AMENDMENTS TO THE DRAWINGS:

REMARKS

Fig. 1

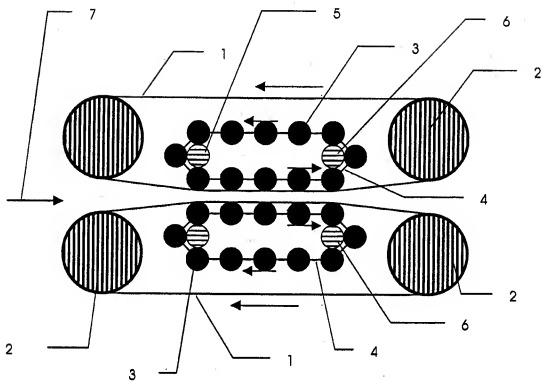
•The "positioning means" in claim 8 corresponds with the output shaft 6 shown in Figure 1 and referenced at page 7, line 8. The positioning function is described more fully in the subsequent paragraph at page 8, lines 29-34 as follows.

Fig. 3

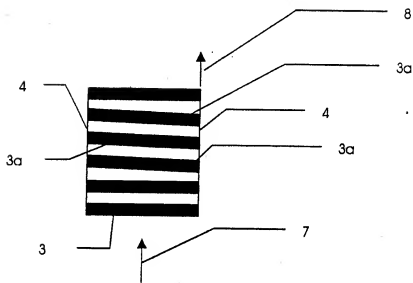
According to the invention, this deviation is counteracted by, for example, temporarily aligning the output shaft not shown in Figure 3 in the opposite diagonal direction, i.e., according to Figure 3, shifting it on the right side in the direction of the arrow 8 in order to thus compensate the slant of the rotating rod 3a.

Fig. 4

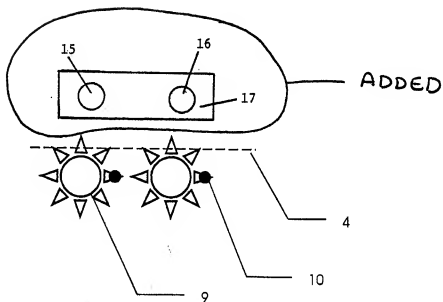
The attached sheets of drawings include changes to FIG. 4. This sheet, which includes FIGS. 3 and 4, replaces the original sheet including FIGS. 3 and 4. In Figure 4, sensors 15 and 16 and evaluation device 17 are schematically shown and added to the drawing.

•The "sensors" and "evaluation device" recited in claims 8 and 10 are now shown in amended Figure 4. Particularly, the sensors 15 and 16 together with the evaluation device 17 are schematically shown. These elements were originally described in the application and the specific discussion at page 9 has been amended herein to include the reference numerals. The amendment of the drawing does not raise new matter issues as the elements and their functions were described in the application as originally filed.
